REMARKS

Claims 1-28 were examined in the Office Action mailed September 12, 2006.

As shown in the annotated portion of Fig. 2 below, “the connecting flange portion [identified as “A” in the annotated drawing] connects a radially outer region of the hub portion [“B”] to a radially inner region of the friction portion [“C”]

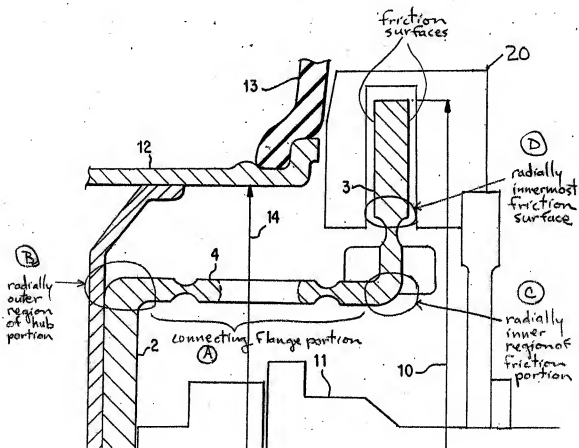
- Objection to the drawings for failing to illustrate the claim 1 limitation of “the friction portion radially inward from a radially innermost friction surface of the friction portion.”
- Rejection of claims 1-28 under 35 U.S.C. § 112, second paragraph, as indefinite on the ground that it is not clear which feature of the present invention is the “friction portion radially inward from a radially innermost friction surface portion.”
- Rejection of claims 1-28 under 35 U.S.C. § 103(a) as unpatentable over newly-cited U.S. Patent No. 3,958,671 to Muller (“Muller”) in view of U.S. Patent No. 5,222,568 to Higasa, *et al.* (“Higasa”).
- Rejection of claim 16 on the grounds of nonstatutory obviousness-type double patenting as unpatentable over claim 2 of U.S. Patent No. 7,255,205 to Plantan, *et al.* (“Plantan ‘205”)

1. **The Recited Feature Is Shown In The Drawings.** The Applicants respectfully traverse the objection to drawings for failing to illustrate the claim 1 limitation of “the friction portion radially inward from a radially innermost friction surface of the friction portion,” on the ground that this feature is illustrated in the drawings.

radially inward from a radially inner-most friction surface ["D"] of said friction portion [the friction surfaces are identified below, within caliper 20]."

In view of the above, the Applicant submits that the recited feature is adequately illustrated in the figures, and no corrected drawing is required. Reconsideration and withdrawal of the drawing objection, and the associated § 112, second paragraph, rejection of claims 1-28, is respectfully requested.
